PUBLIC INTEREST REVIEW FOR GROUND WATER APPLICATIONS

Date 7 November 2012FROM: Ground Water/Hydrology Section Gerald H. Grondin

SUBJECT: Application G-17572

A. **GENERAL INFORMATION:** Applicant's Name: Dennis & Pamela Amsbaugh County: LakeA1. Applicant(s) seek(s) 1.99 (895 gpm) cfs from 1 well(s) in the Goose and Summer Lakes Basin,
Goose Lake sub basin Quad Map: Crane CreekA2. Proposed use: Primary Irrigation (430 acres) Seasonality: 1 March to 31 October (245 days)

Transient Stream Depletion (Jenkins, 1970; Hunt, 1999)

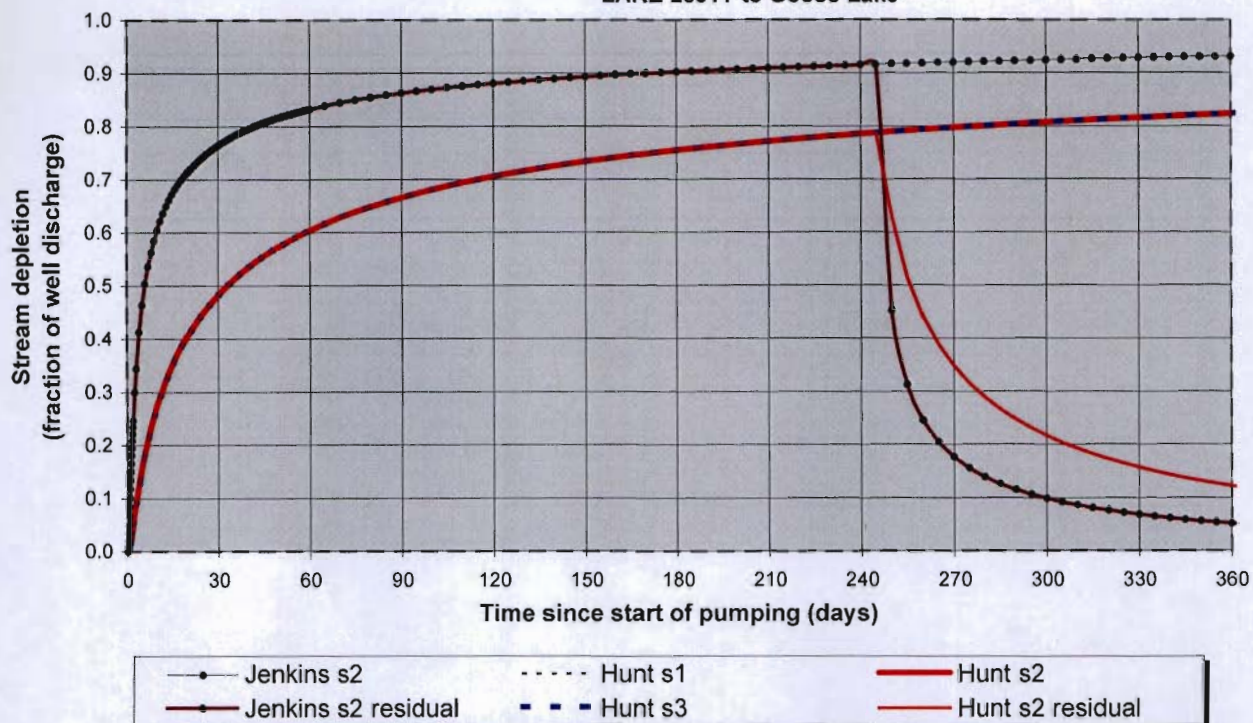
Hunt (1999) was used to calculate the interference with Goose Lake. The parameters used were a horizontal hydraulic conductivity of 10 feet/day (transmissivity = 5000 ft²/day based on specific capacity data for LAKE 2840, LAKE 2845 and LAKE 3066), 0.001 for the storage coefficient, a stream width of 3000 feet (less than the actual lake width given the model became unstable with a more appropriate larger width), a streambed conductivity of 0.02 feet/day and a streambed thickness of 50 feet (both from Morgan (1988)). The transmissivity parameters are within the ranges found in Morgan (1988) and in Gonthier (1985). They are higher than determined for the immediate Lakeview vicinity. A pumping rate of 1.99 cfs (895 gpm) was used. This pumping rate is the maximum rate requested. It was used, because it is less than a pro-rated rate (2.65 cfs) based on the total volume requested (1290 ac-ft) divided by the total irrigation period (245 days).

A potential for substantial interference with Goose Lake is assumed given the well is less than 1-mile from the lake and the calculated interference is more than 25 percent of the rate of appropriation. The percent interference is the same for any pumping rate.
